Commentary on Codenext draft, 6/13/17  
By Travis G. Young, AIA

I have reviewed the Codenext draft with an eye to establishing its consistency and or contrast with existing code entitlements. I have done this by testing past and current residential design projects that have been approved under current zoning regulations, against the new code requirements. This testing has focused on the Brentwood Neighborhood where I have completed over two-dozen residential projects including many ADU's and Duplexes.

Site Plan  
A1 of 8

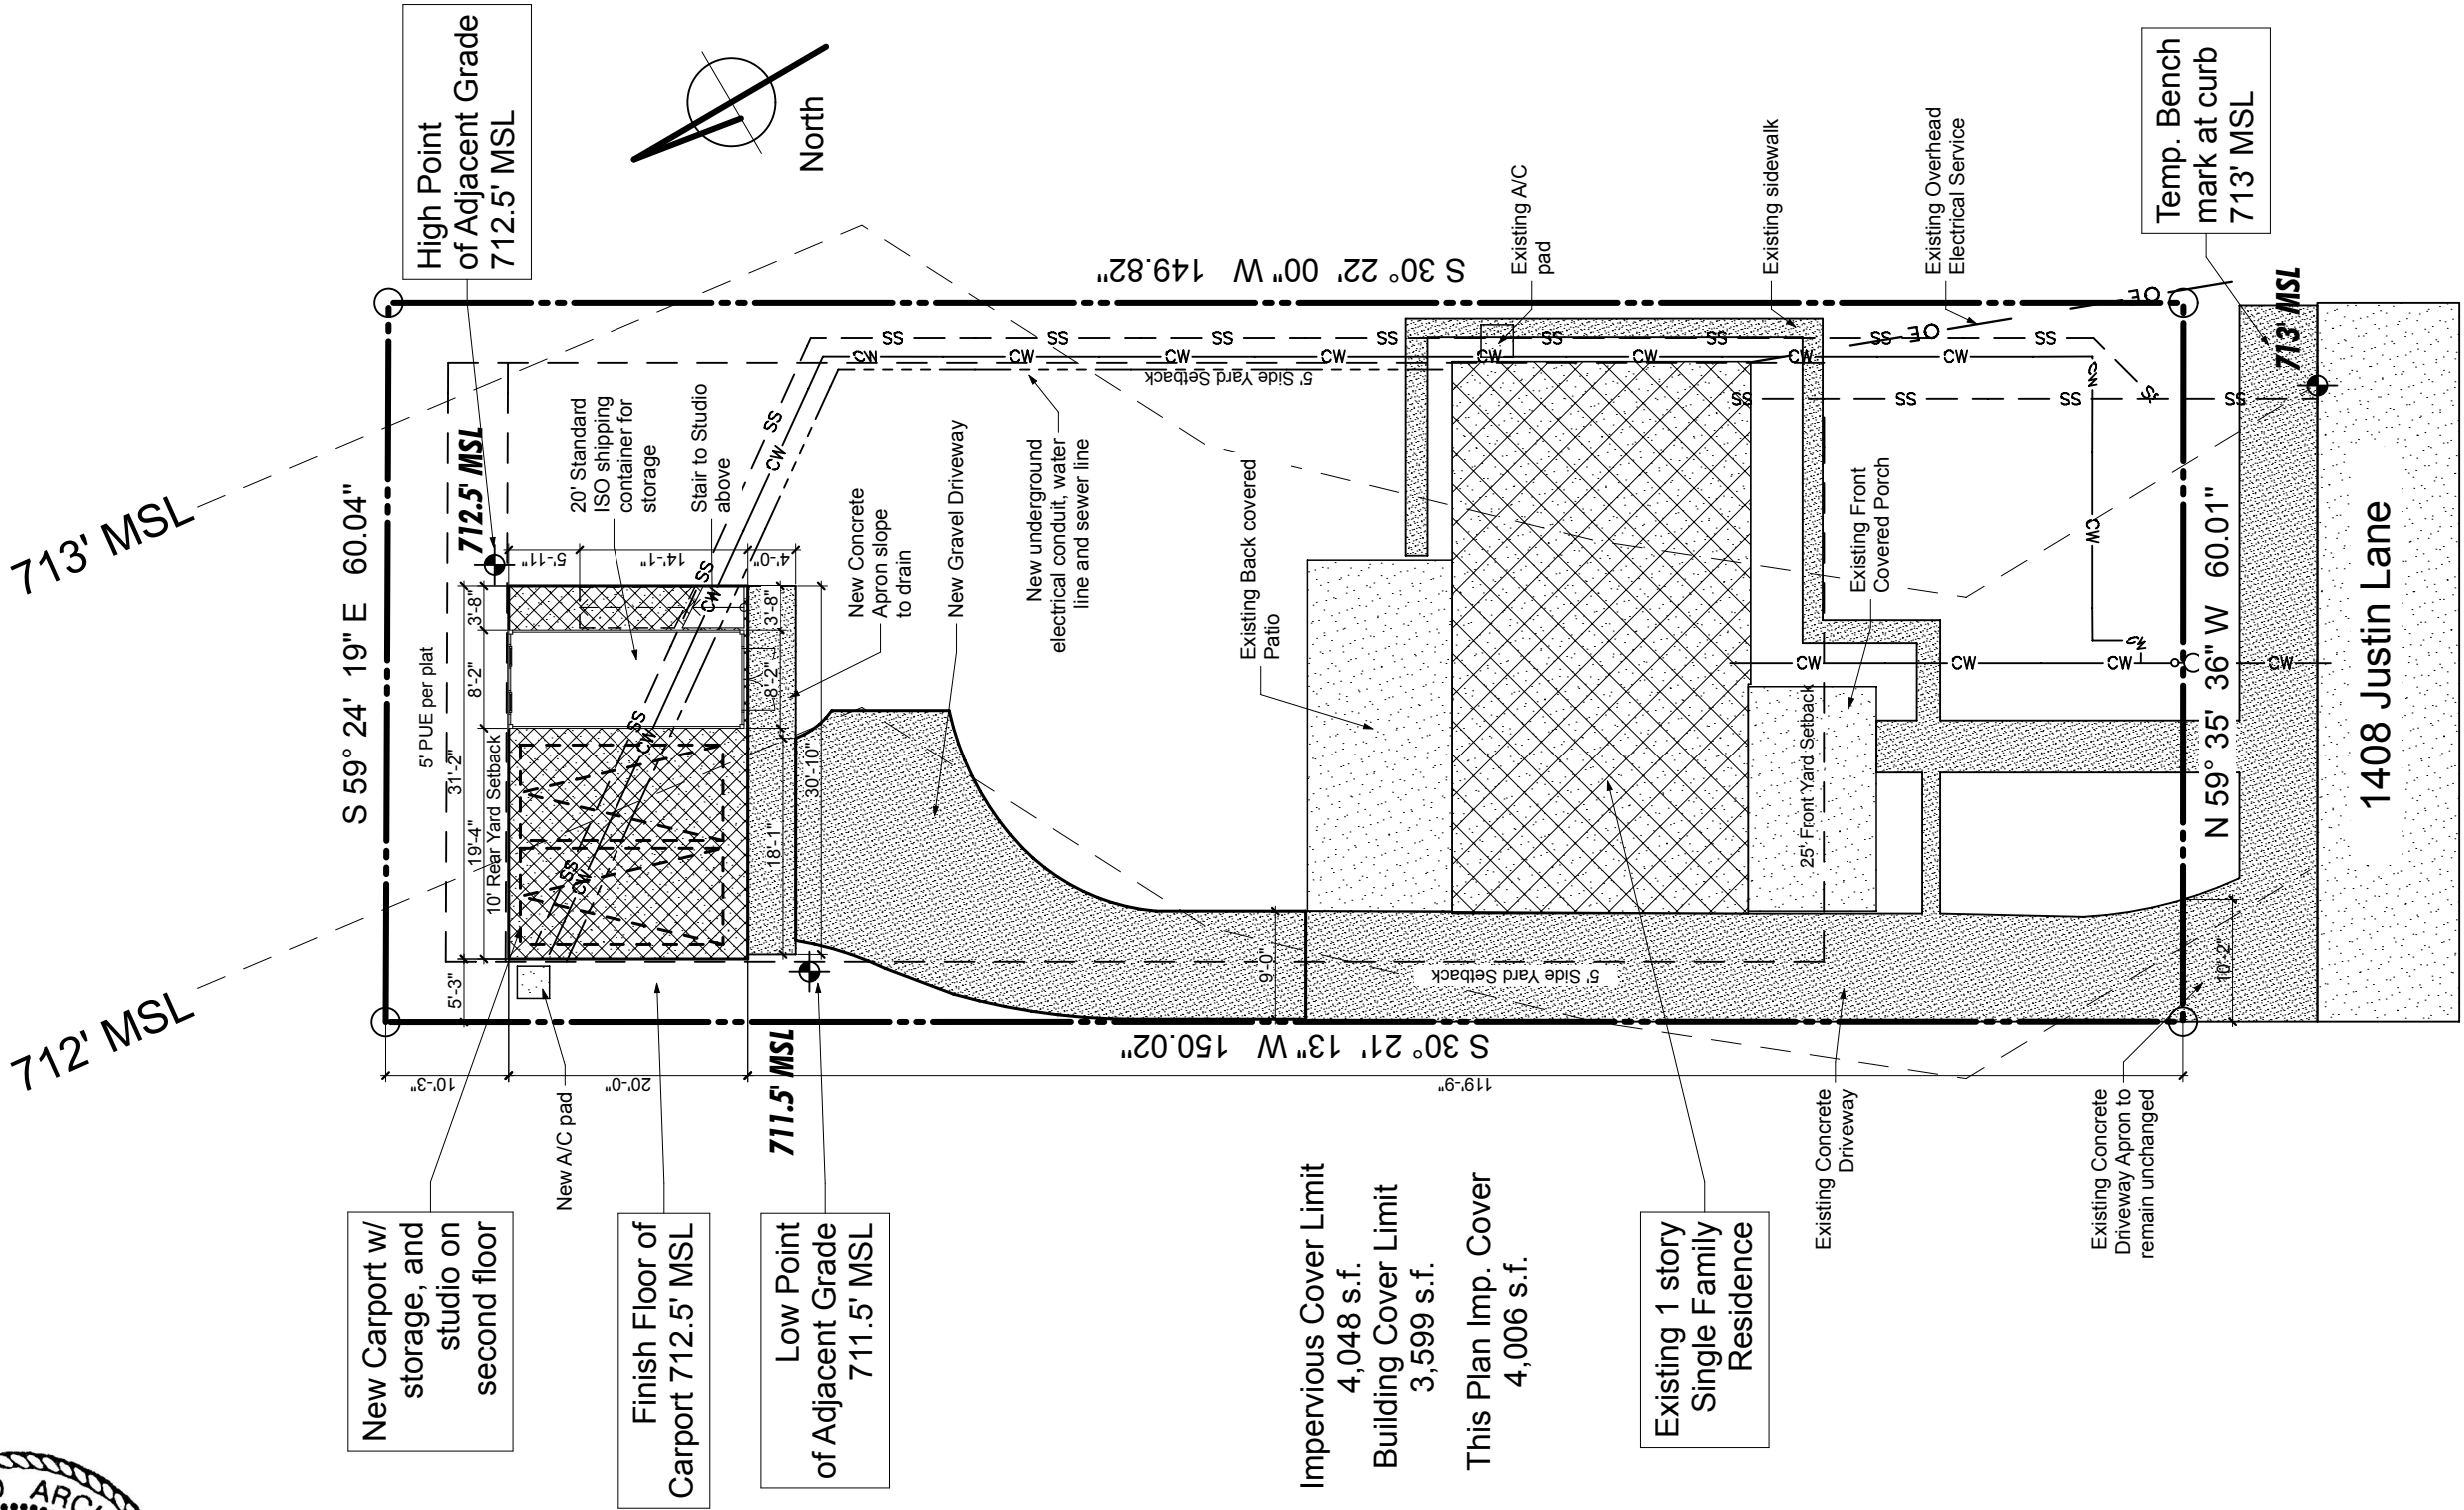
1408 Justin Lane ADU, would be considered non-conforming due to rear yard setback. This project was completed in 2016. Site plan and picture included.
